**CITY OF TEMPE
DEVELOPMENT REVIEW COMMISSION**

Meeting Date: 10/13/2015
Agenda Item: 3

ACTION: Request for a Development Plan Review consisting of a new 7,753 square-foot emergency medical clinic for **ARIZONA GENERAL HOSPITAL EMERGENCY ROOM (PL150272)**, located at 5125 South Rural Road. The applicant is Kimley-Horn.

ARIZONA GENERAL HOSPITAL EMERGENCY ROOM
 SITE PLAN
 5125 S. RURAL ROAD
 TEMPE, ARIZONA

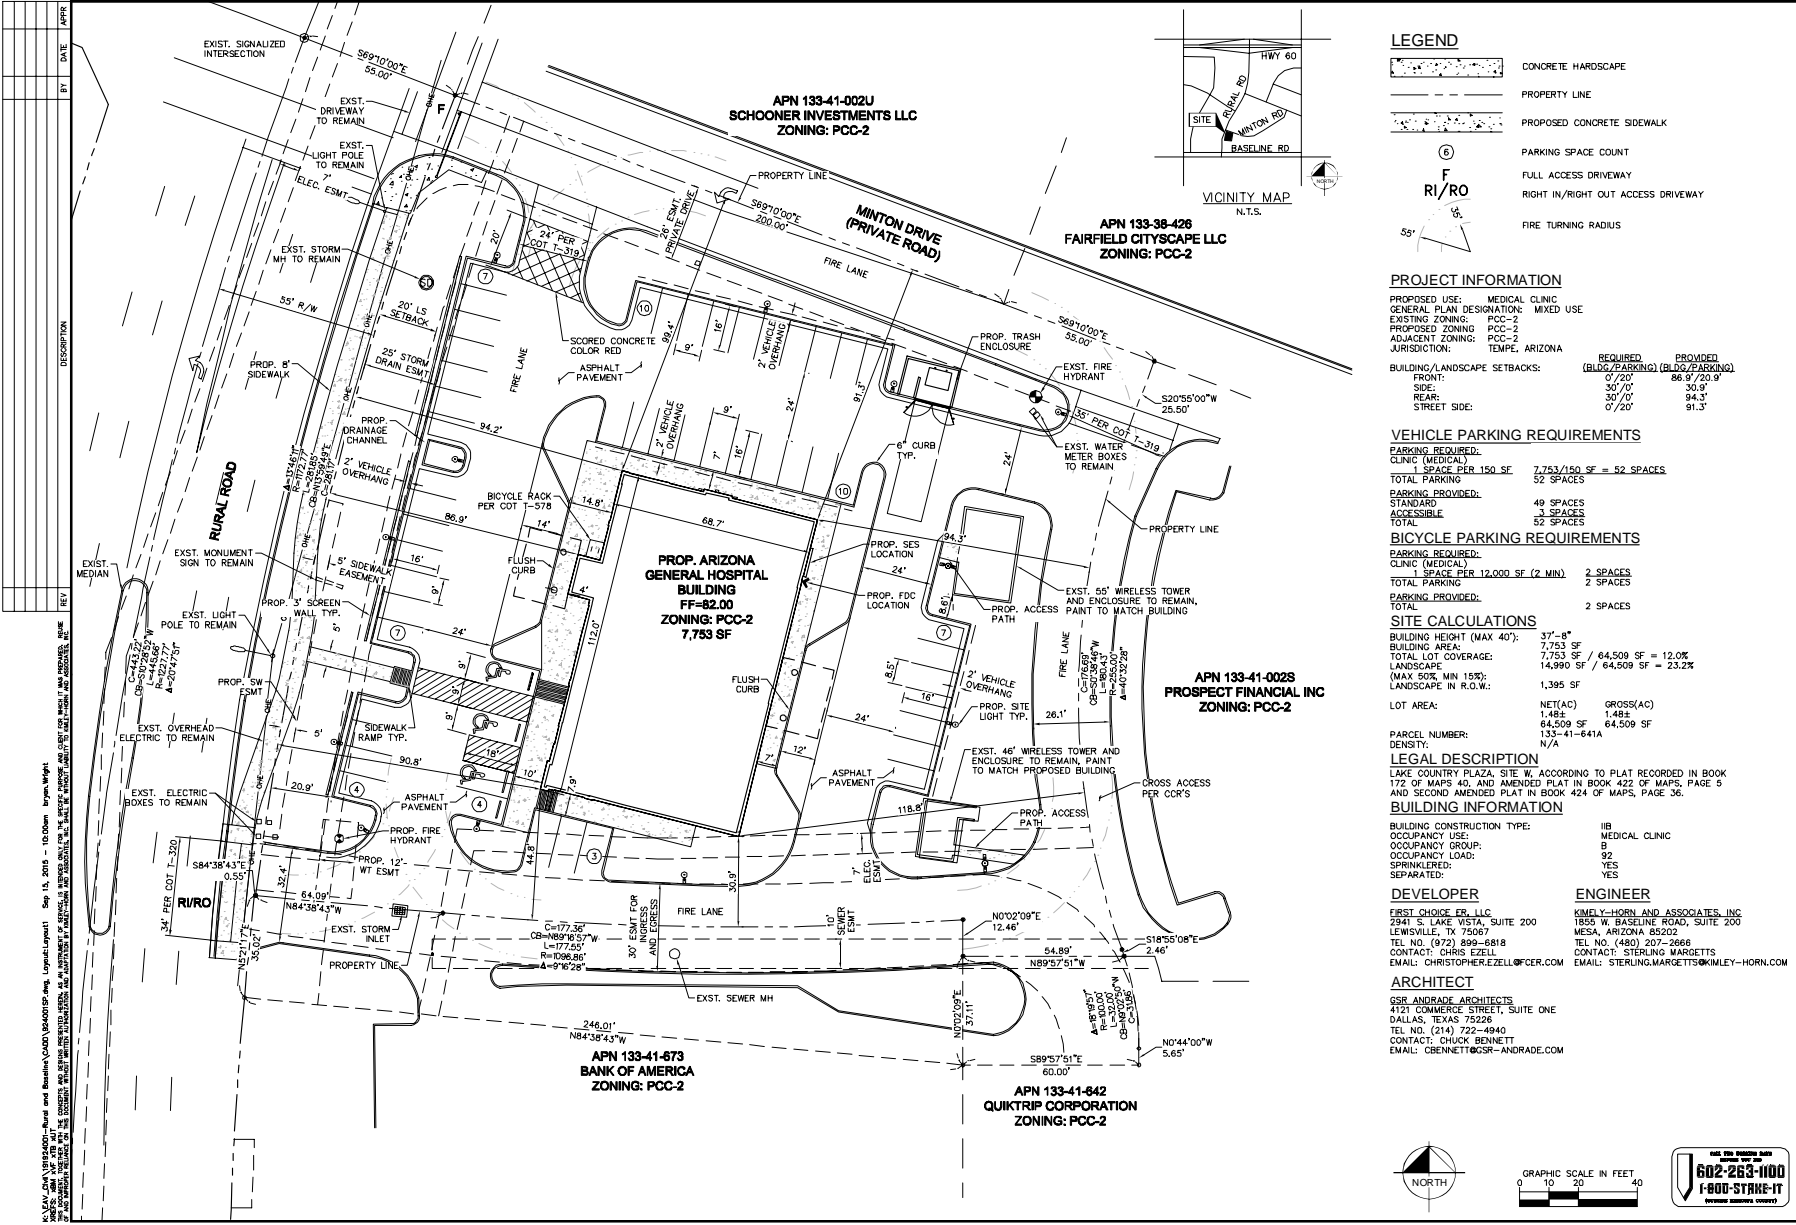
- September 2, 2015: Formal application was submitted. Comments made by staff included: provide a minimum 8' wide, detached sidewalk along Rural Road; texture and paint the existing wireless facility enclosures to match the new building; provided upgraded paving at driveways; incorporate Swan Hill Olive and Pine trees into the project to maintain the existing landscape theme of Lake Country Plaza; clarify what the vertical and horizontal lines are on the elevations; clarify what the diamond elements are on the elevations; provide more substantial canopies over the windows that better compliment other building elements.

6. Locate a "no left turn" sign on the north side of the driveway on Rural Road.
7. Locate a "no left turn" sign on the east side of the western-most driveway on Minton Drive.

8. The two bicycle racks shall be replaced with a single rack that provides two bicycle parking spaces.
9. Increase the width of the landscape island on the west side of the refuse enclosure to a minimum of 7'.

10. The site plan shall be modified to note the maximum lot coverage of 50%.
11. The site plan shall be modified to eliminate the "max 50%" note under the landscape area.

ARIZONA GENERAL HOSPITAL EMERGENCY ROOM
 LANDSCAPE PLAN
 5125 S. RURAL ROAD
 TEMPE, ARIZONA

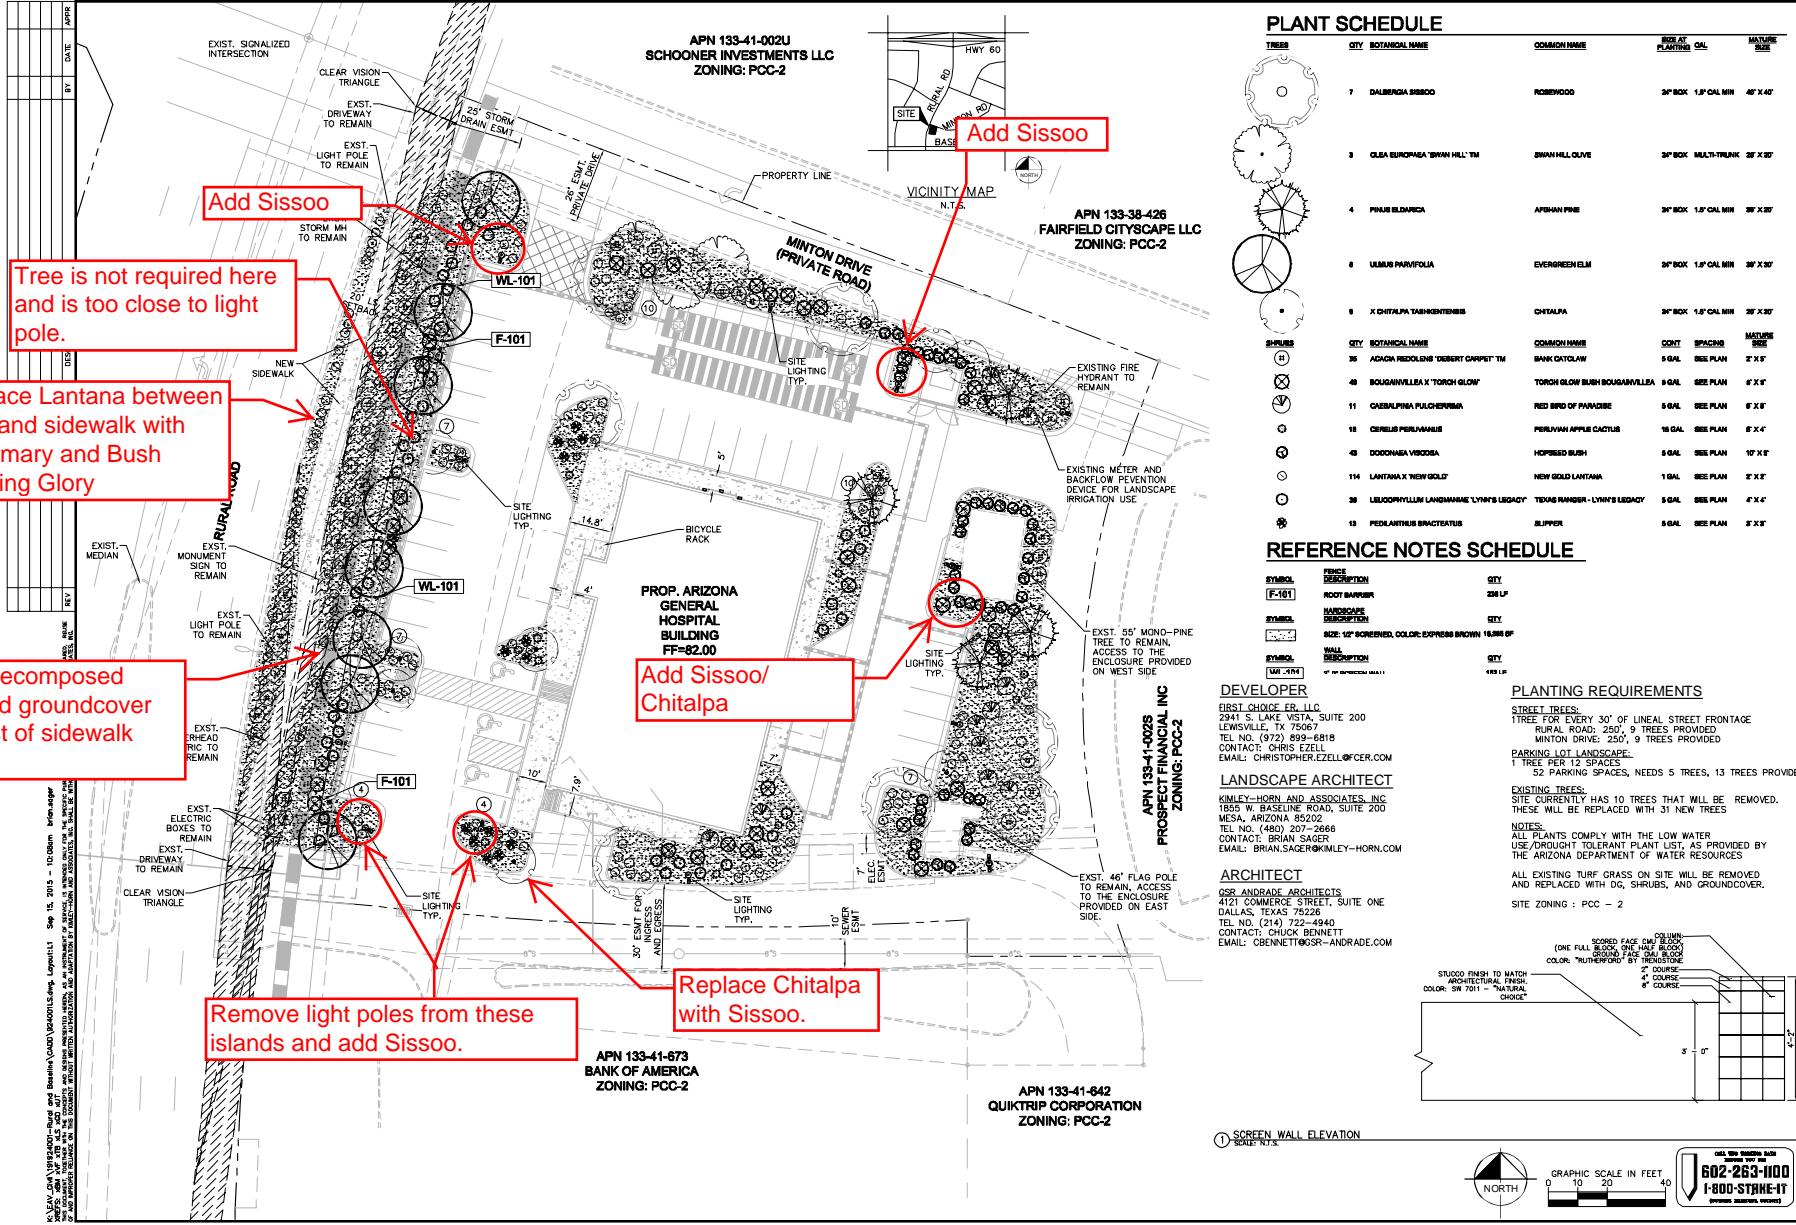
The sidewalk along Rural Road will be reconstructed with an 8' width and a 4.5' wide landscape strip between the curb and sidewalk. The landscape plan identifies Lantana and Bank Catclaw in the strip, which can spread too much in a narrow area; a stipulation requires the elimination of Lantana and replacement with a mixture of Prostrate Rosemary and Bush Morning Glory.

East of the sidewalk along Rural, the plan identifies decomposed granite and a mixture of vegetative ground cover. In order to maintain the existing landscape character along Rural, a condition is included to eliminate the decomposed granite and ground cover along the street frontage and replace them with turf. The proposed Evergreen Elm trees identified on the plan would remain. Along Minton Drive, the plan shows a mixture of trees that include Swan Hill Olive and Afghan Pine to maintain the character of Lake Country Plaza and better blend the existing monopine wireless facility with the new development.

Several trees required within parking lot landscape planters are either missing, too small, or too close to light poles. Conditions are included to modify the plan and address these items. A marked- up landscape is also attached to demonstrate the conditions.

26. Arterial street trees shall be a minimum of 36" box specimens and a minimum of 1 1/2" caliper trunk.
27. Replace the New Gold Lantana between the curb and sidewalk with Prostrate Rosemary and Bush Morning Glory.

28. Along the Rural Road street frontage, east of the sidewalk, replace the decomposed granite, shrubs, and ground cover plants with turf.
29. Add and/or substitute trees in the five parking lot landscape islands as shown on the attached redlined landscape plan.

30. Eliminate the Chitalpa tree within a landscape island, as identified on the redlined landscape plan. Alternatively, relocate the light pole to be a minimum 20' from tree trunks.

02 South Elevation
SCALE: 1/8" = 1'-0"
2129-11

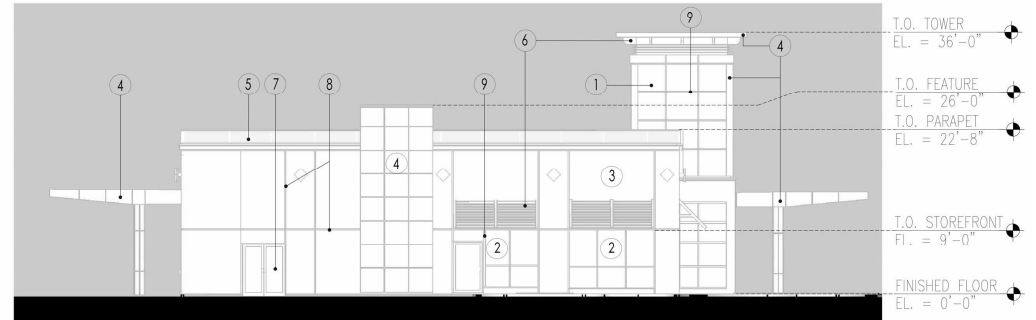
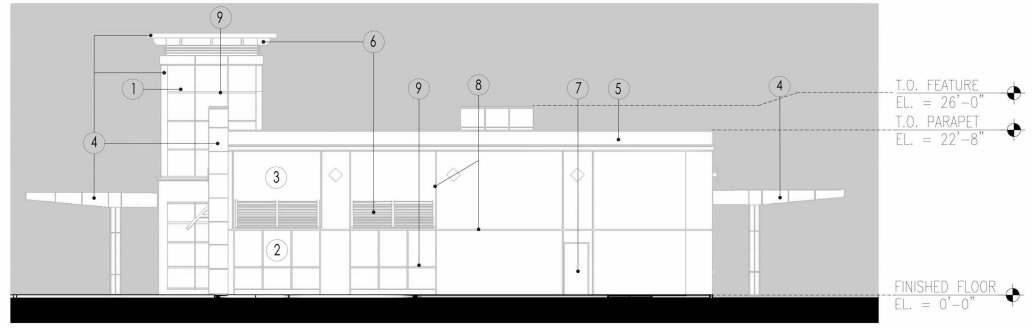
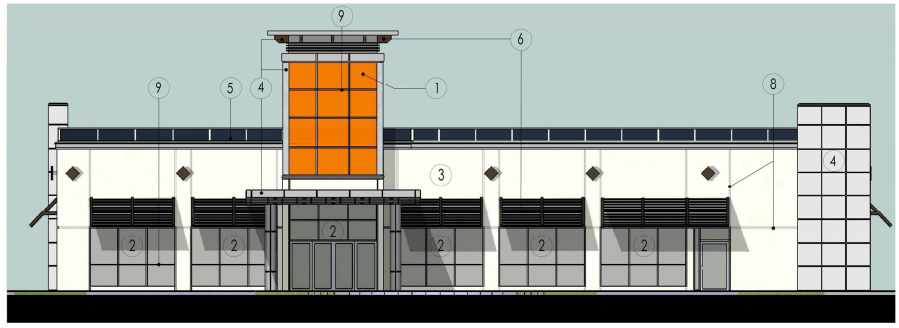
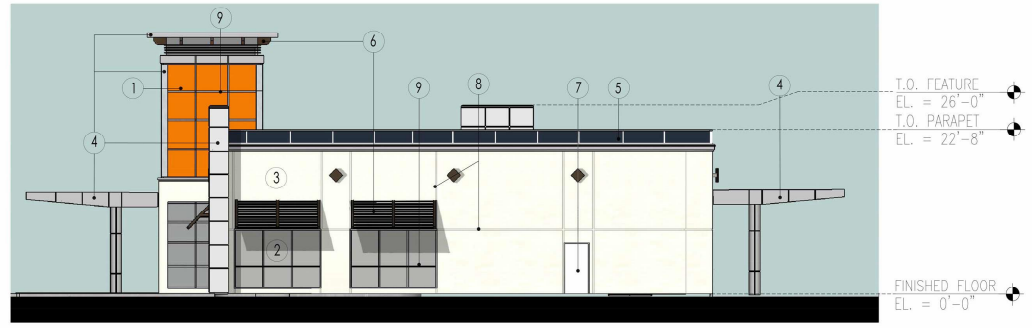
The building design includes sand finish stucco with aluminum composite wall panels. The elevations depict vertical and horizontal lines that form patterns in the stucco. These are noted as control joints. In order to ensure that the lines are visible wall details, a stipulation is included to require that they also be reveals. Diamond-shaped light sconces provide accent lighting on all elevations. The building is topped with gray spandrel glass, and the entrance on the west elevation is emphasized with an orange glass tower element.

Aluminum canopies with bronze finish are located over the windows, and clear anodized aluminum canopies are located over the customer and ambulance entrances. The window canopies are pitched with an open trellis design, which looks out of character with the straight, blocky building elements. A stipulation is included to require a horizontal projecting canopy that can either be open trellis or solid, but has a solid canopy fascia.

13. The window canopies shall project horizontally from the building and be either open trellis or solid with a solid fascia to mimic the entrance canopy. Canopies may be bronze aluminum or clear anodized aluminum.

14. The stucco control joints (elevation note #8) shall also be noted as reveals. Reveals shall be a minimum one-quarter of an inch (1/4") deep and a minimum one-half of an inch (1/2") wide.

15. On the south elevation, a vertical reveal shall be added on the right side of the center diamond-shaped light fixture.
16. The finished floor height shall be corrected to 1'-8". The building height shall be corrected to 37'-8" to top of tower.

17. The material and color legend shall be modified to include the diamond-shaped light fixtures.
18. Provide secure roof access from the interior of the building. Do not expose roof access to public view.
